To: INCITS Technical Committee T11
From: Fred Knight, Network Appliance
Email: knight@netapp.com
Date: 2 March, 2009
Subject: FC-BB5 Letter Ballot comment resolution

This proposal addresses concerns in the following letter ballot comments:

Figure 6.A - FC-BB_E Single Port VE_Port/VF_Port functional model

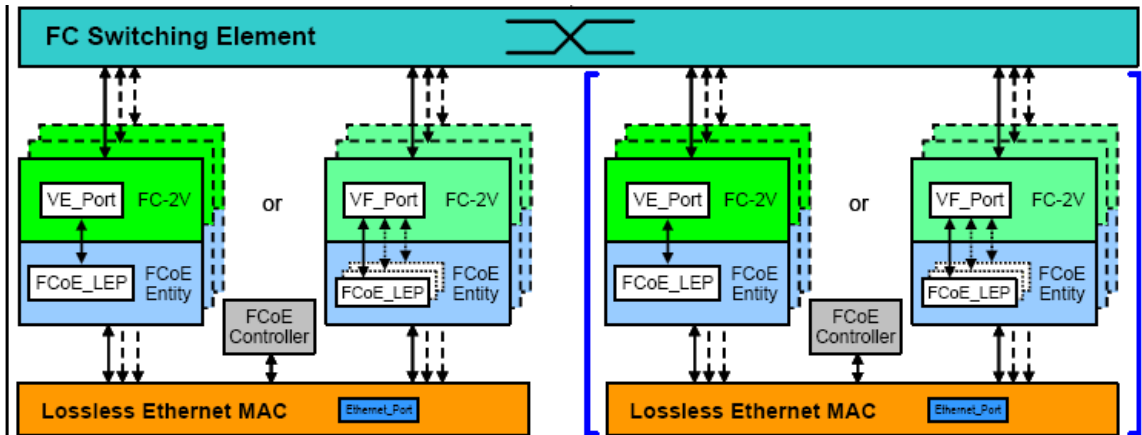
Figure 30.A shows the functional model of a single port FCF. Figure 30 shows the functional model of a multi-port FCF, where the bracketed functional components are optional. An FCF is functionally composed of a Fibre Channel Switching Element (see FC-SW-4) with at least one Lossless Ethernet MAC (FCF-MAC). Each FCF-MAC shall be coupled with an FCoE Controller function. Each FCF-MAC may be coupled with a Lossless Ethernet bridging element. The Fibre Channel Switching Element may be coupled with a Fibre Channel Fabric interface, providing native E_Port and F_Port connectivity. An FCF forwards FCoE frames addressed to one of its FCF-MACs based on the D_ID of the encapsulated FC frames.

Figure 6 - FC-BB_E Multi-Port VE_Port/VF_Port functional model

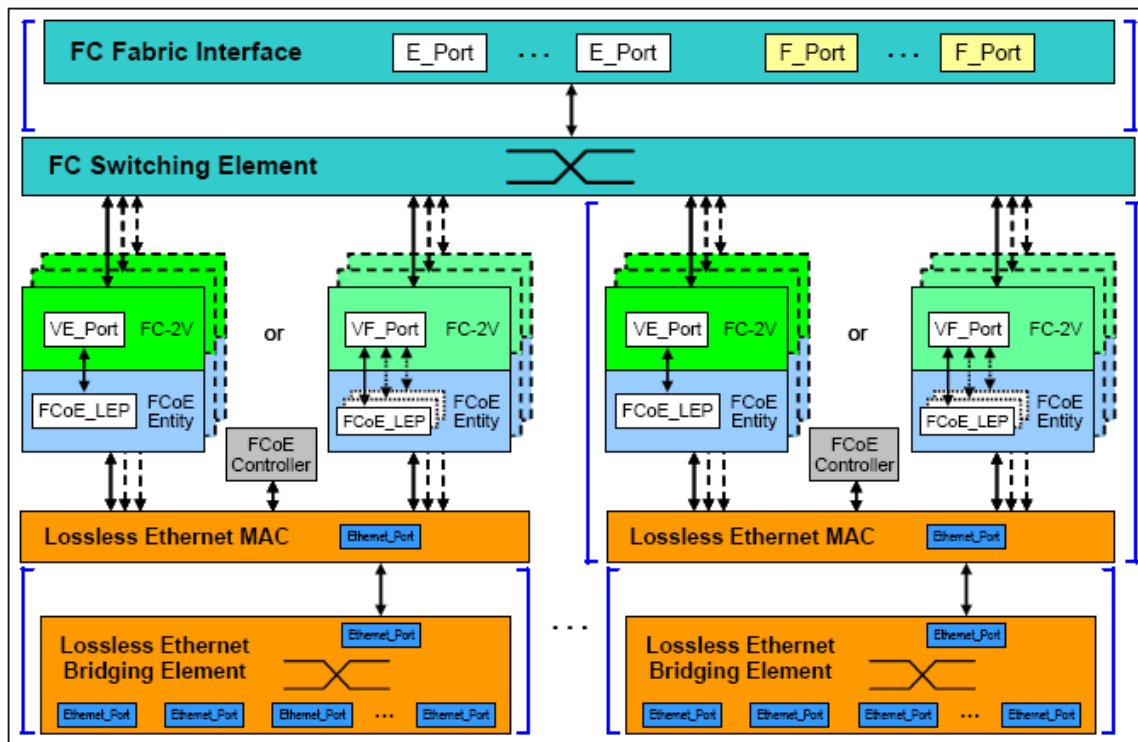
NOTE 2 – Other combinations of Lossless Ethernet bridging elements and Lossless Ethernet MACs connections are allowed.

When an FCF includes Lossless Ethernet bridging elements, an FCF-MAC address may be used by multiple Ethernet ports of the FCF.
